South Texas Project
Units 3 and 4
Docket Nos. 52-012 and 52-013
Supplemental Response to Request for Additional Information

RAI 02.03.01-24, Supplement 4

RAI 02.03.01-24, Supplement 4**QUESTION:**

3H.11 Design for Site-Specific Hurricane Winds and Missiles

Figure 3H.11-4 Comparison of Hurricane and Tornado Wind Pressures for Reactor Building

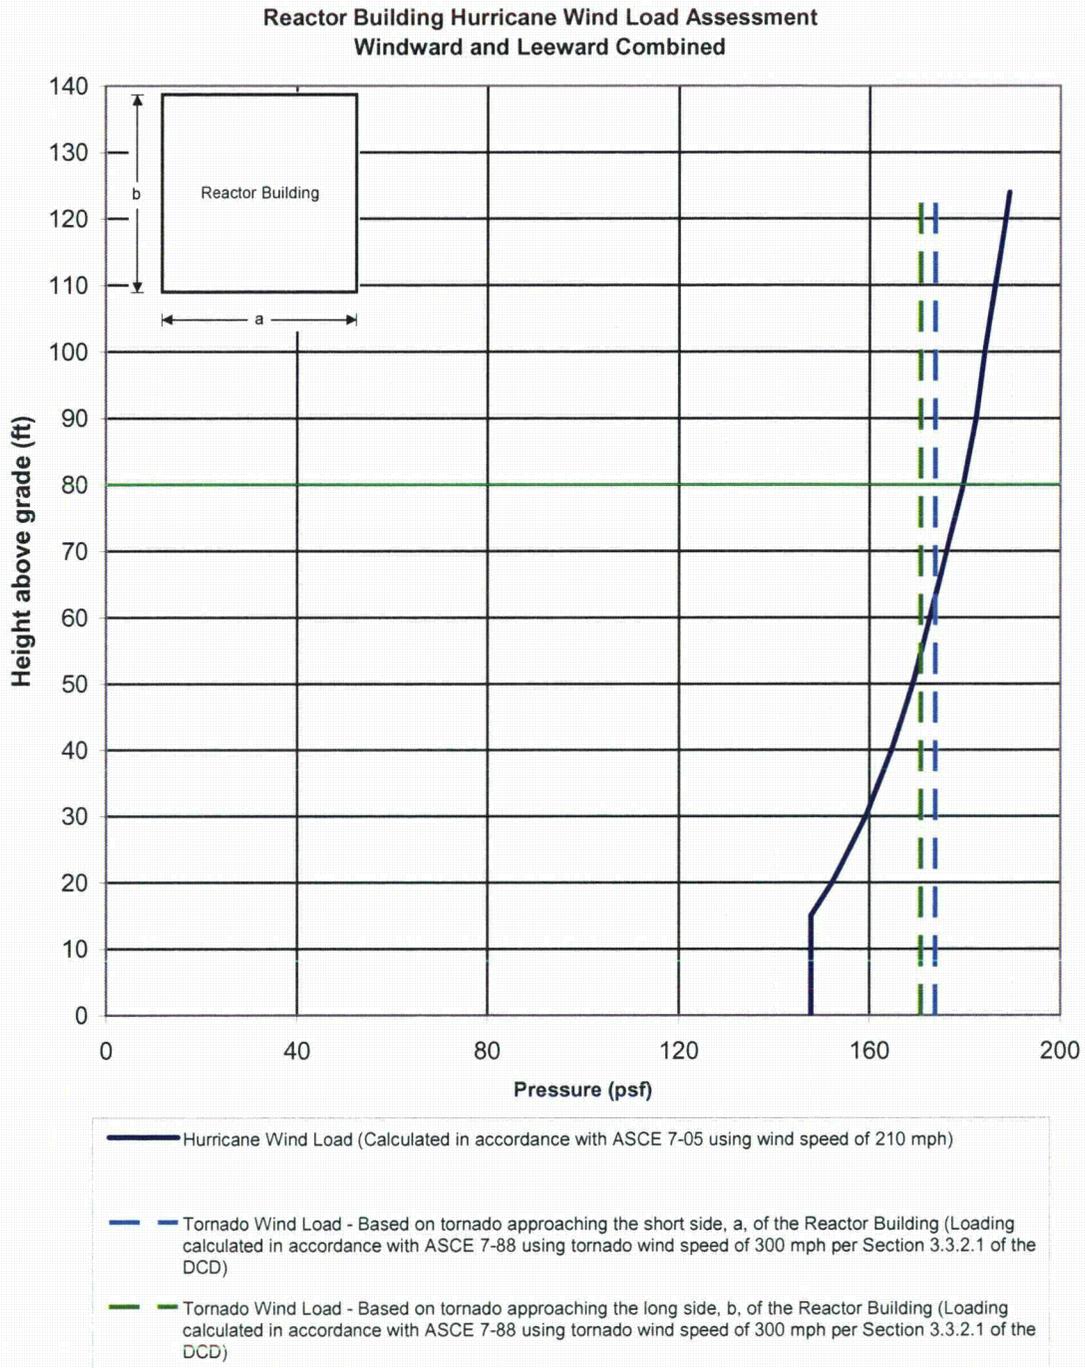
The global hurricane wind pressure on the Reactor Building is enveloped by the global tornado wind pressure from grade up to approximately 60 ft above grade (see Figure 3H.11-4). From approximately 60 ft above grade to the top of the Reactor Building, the global hurricane wind pressure exceeds the global tornado wind pressure. A comparison of the seismic shear versus the total hurricane shear on the Reactor Building shows that the hurricane load is significantly less than the seismic loading (see Figure 3H.11-5). Therefore, the hurricane loading has no impact on the global design or stability. See Table 3H.1-23 for Reactor Building stability.

Figure 3H.11-6 Comparison of Hurricane and Tornado Wind Pressures for Control Building

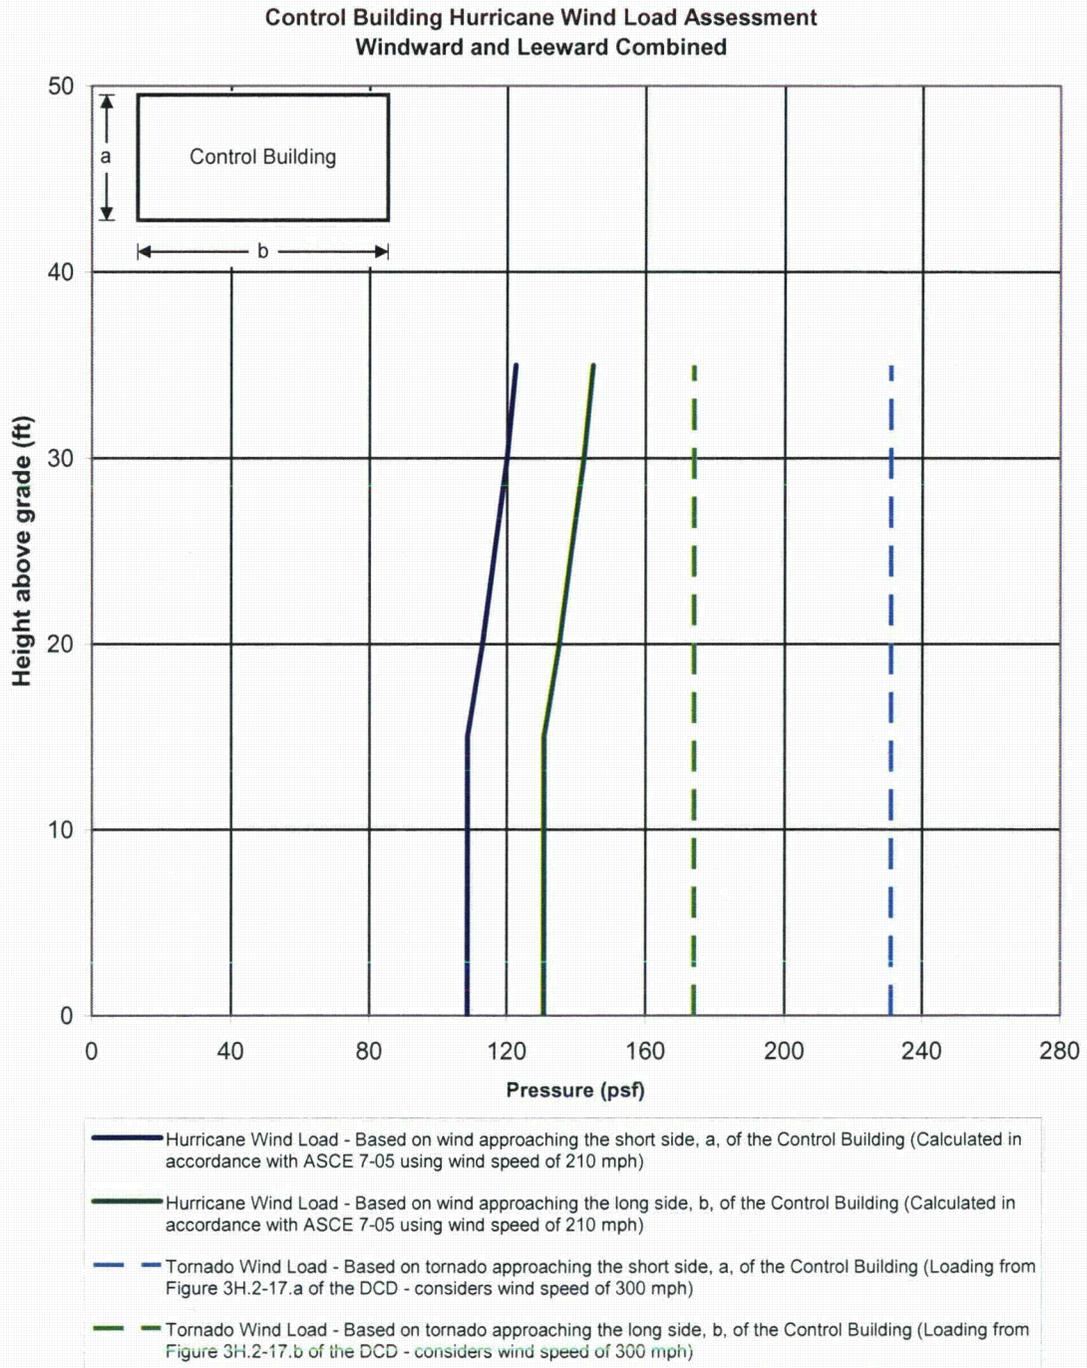
The global hurricane wind pressure on the Control Building is enveloped by the global tornado wind pressure (see Figure 3H.11-6). A comparison of the seismic shear versus the total hurricane shear on the Control Building shows that the hurricane load is significantly less than the seismic loading (see Figure 3H.11-7). Therefore, the hurricane loading has no impact on the global design.

Figure 3H.11-8 Comparison of Hurricane and Tornado Wind Pressures for RSW Piping Tunnels

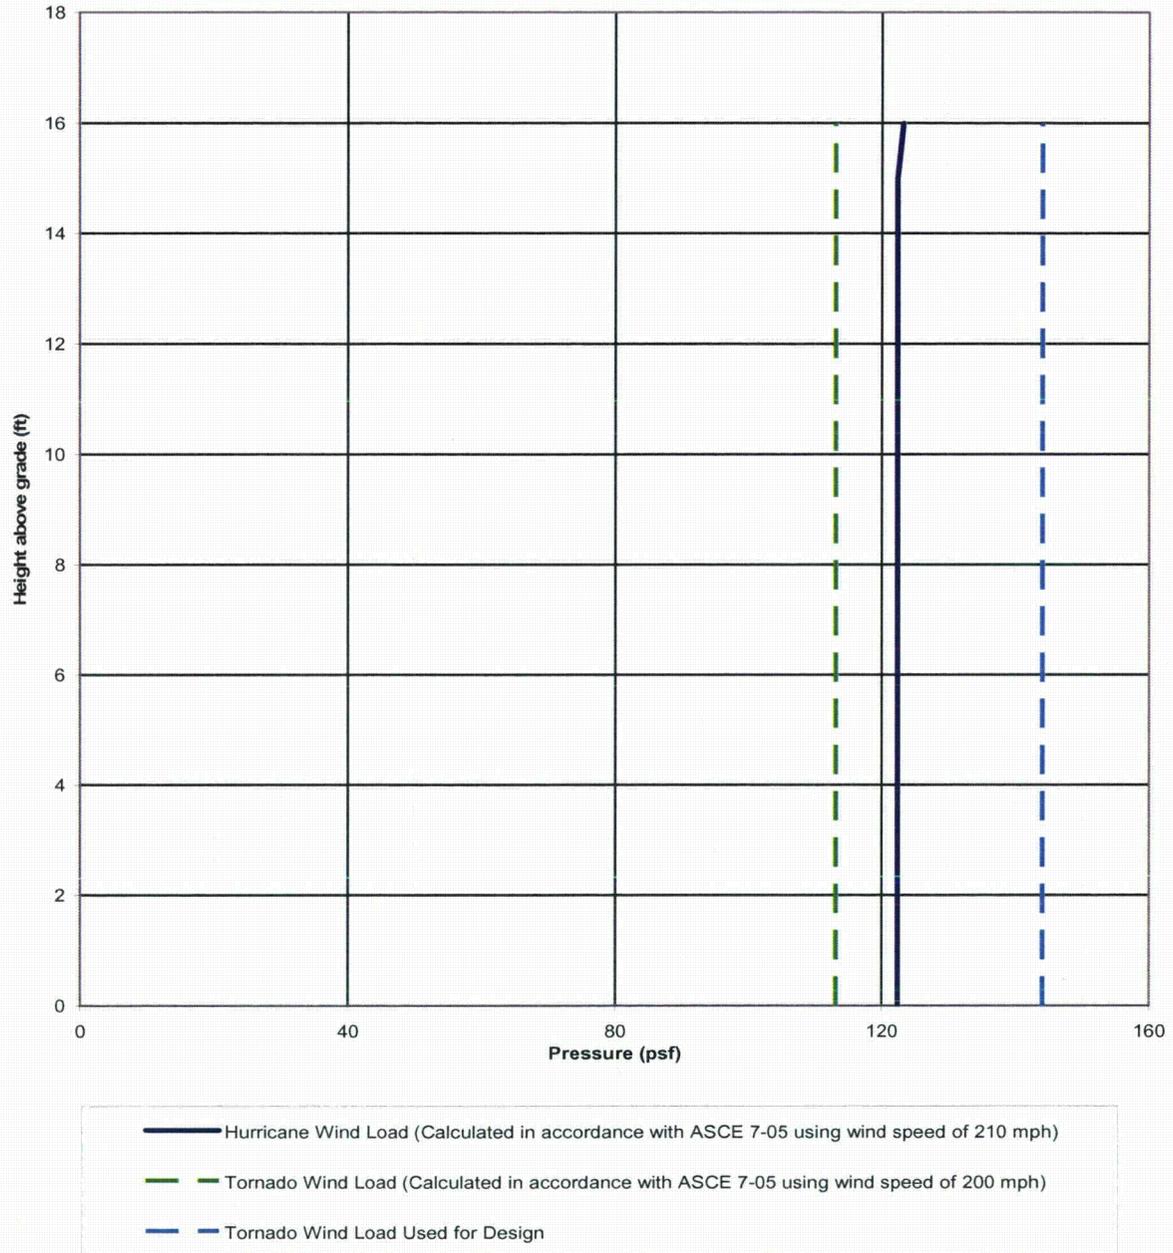
The global hurricane wind pressure on the RSW Piping Tunnel is enveloped by the global tornado wind pressure used for design of the structure (see Figure 3H.11-8).

Figure 3H.11-9 Comparison of Hurricane and Tornado Wind Pressures for RSW Pump House

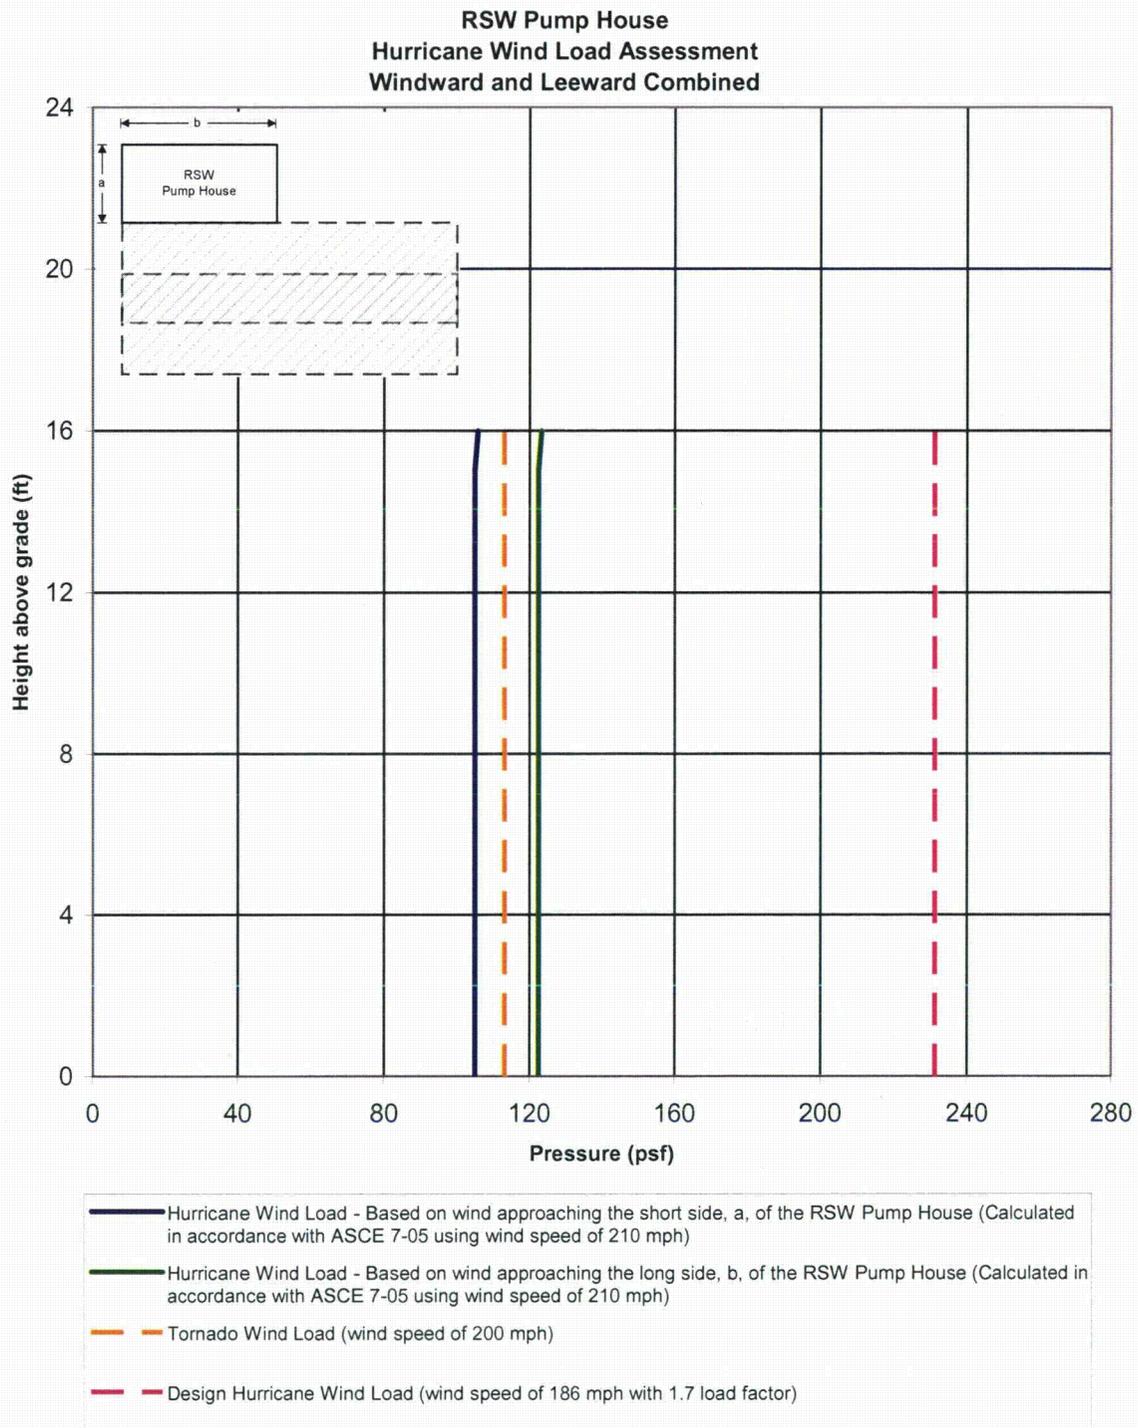
The global hurricane wind pressure on the UHS/RSW Pump House is enveloped by the global hurricane wind pressure used for design of the structure (see Figures 3H.11-9 and 3H.11-10).

Figure 3H.11-11 Comparison of Hurricane and Tornado Wind Pressures for Diesel Generator Fuel Oil Storage Vaults

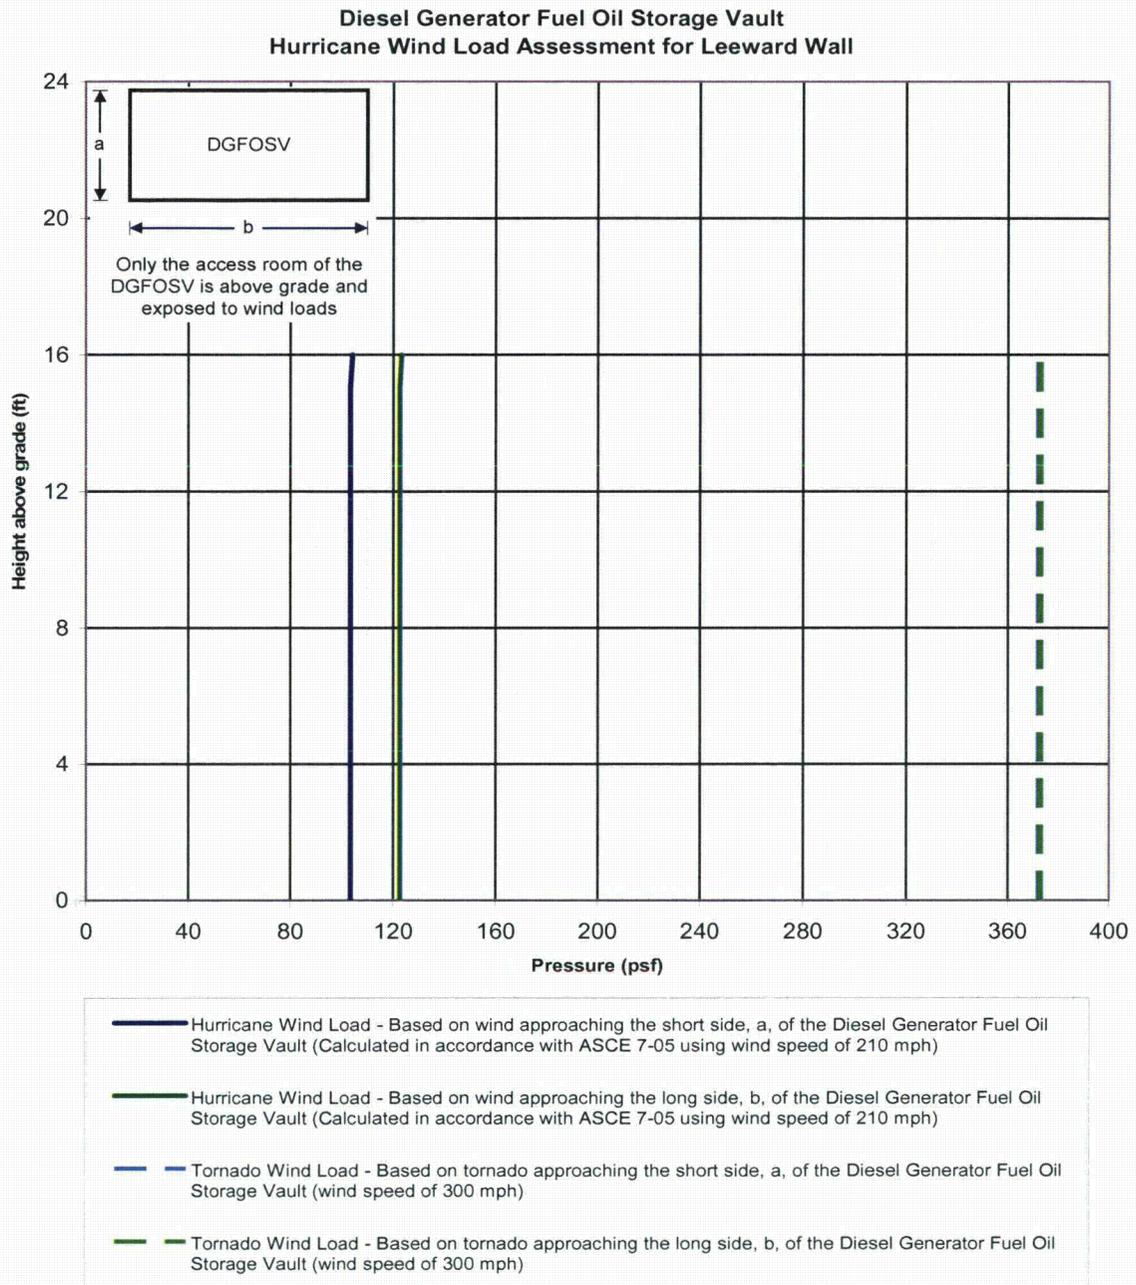
The global hurricane wind pressure on the DGFOSV is enveloped by the global tornado wind pressure used for design of the structure (see Figure 3H.11-11).

Figure 3H.11-12 Comparison of Hurricane and Tornado Wind Pressures for Diesel Generator Fuel Oil Tunnels

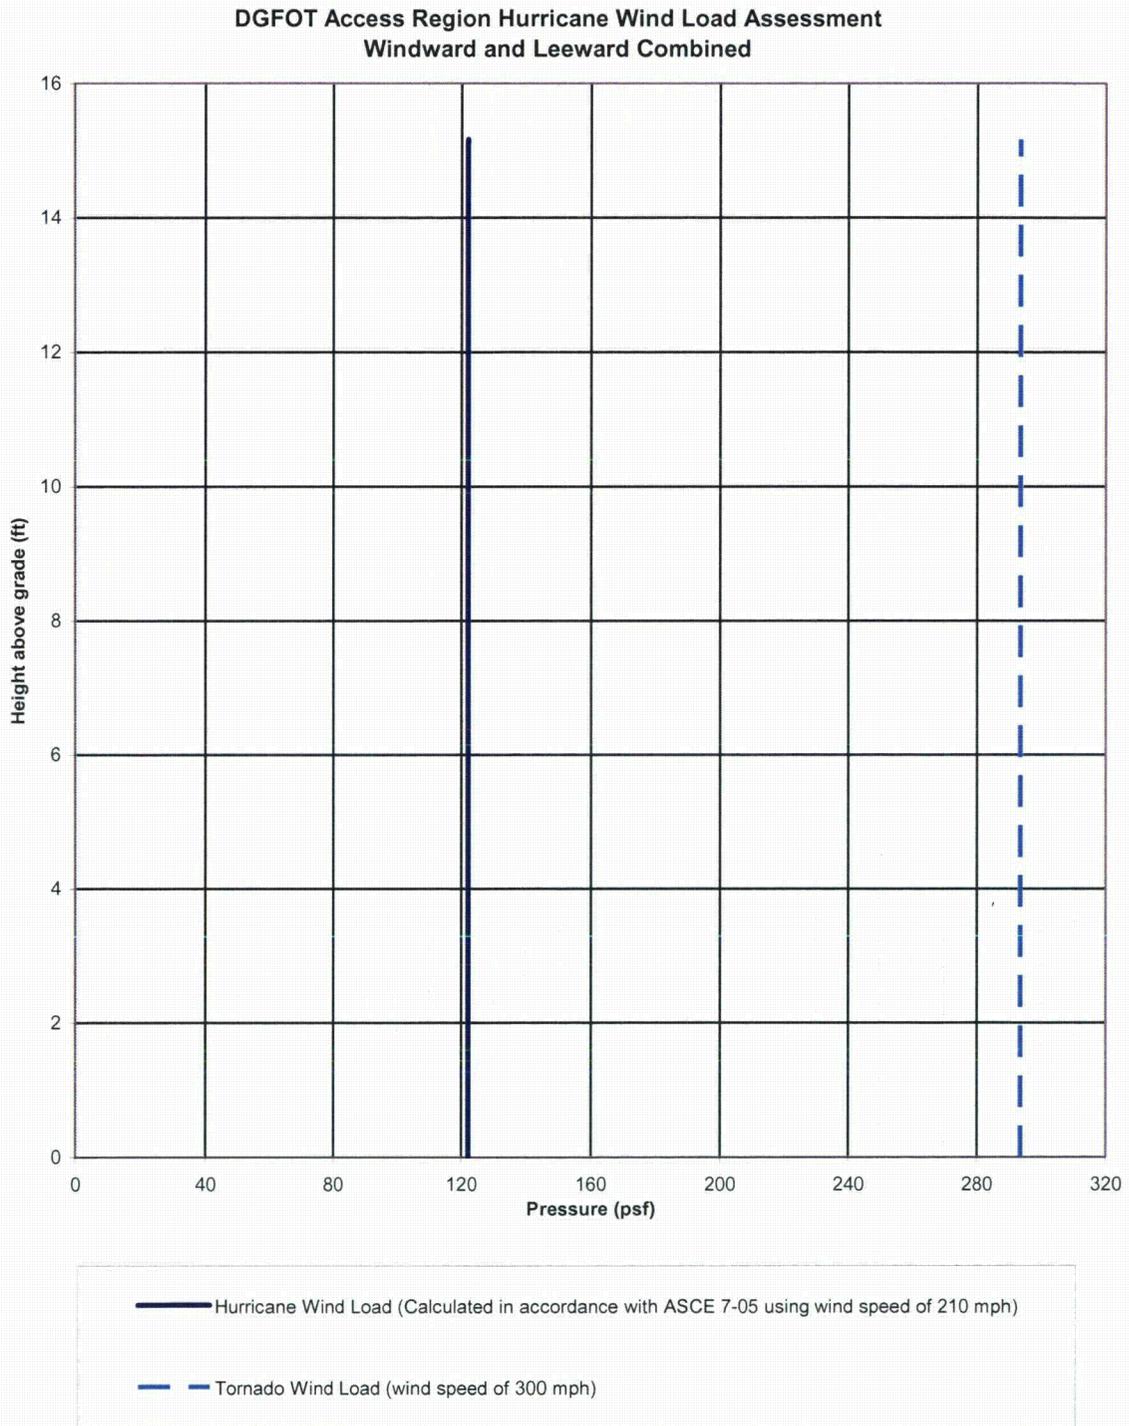
The global hurricane wind pressure on the DGFOT is enveloped by the global tornado wind pressure used for design of the structure (see Figure 3H.11-12).
